MIL-R-83536/26
AMENDMENT 2
18 June 1999
SUPERSEDING
AMENDMENT 1
15 December 1995

MILITARY SPECIFICATION SHEET

RELAYS, ELECTROMAGNETIC, ESTABLISHED RELIABILITY, 6PDT, LOW LEVEL TO 10 AMPERES, PERMANENT MAGNET DRIVE, HERMETICALLY SEALED, ALL WELDED, TRANSIENT SUPPRESSED DC COIL

This amendment forms a part of MIL-R-83536/26, dated 27 March 1992, and is approved for use by all Departments and Agencies of the Department of Defense.

CIRCUIT DIAGRAM

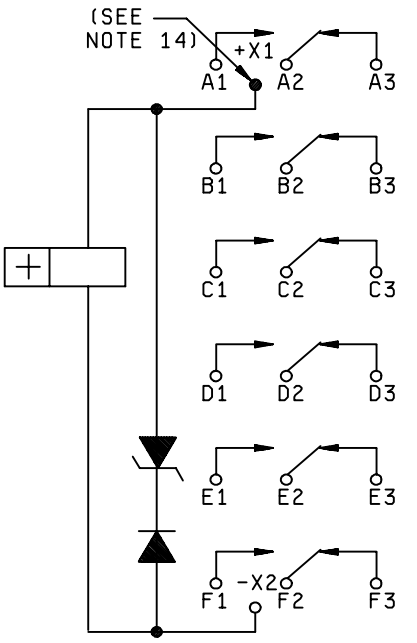
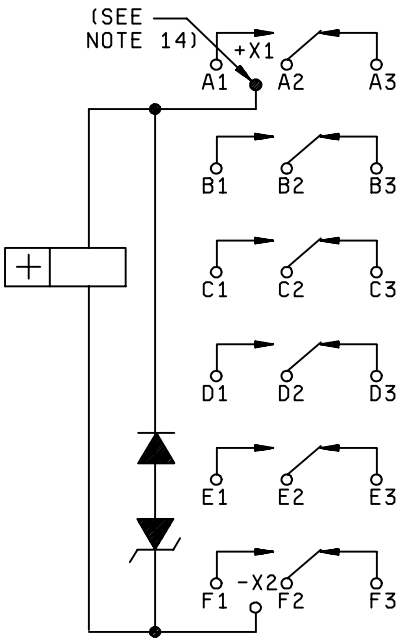
* FIGURE 1, circuit diagram, delete and substitute:

CIRCUIT DIAGRAM
OPTIONAL INTERNAL
DIODE CONFIGURATION
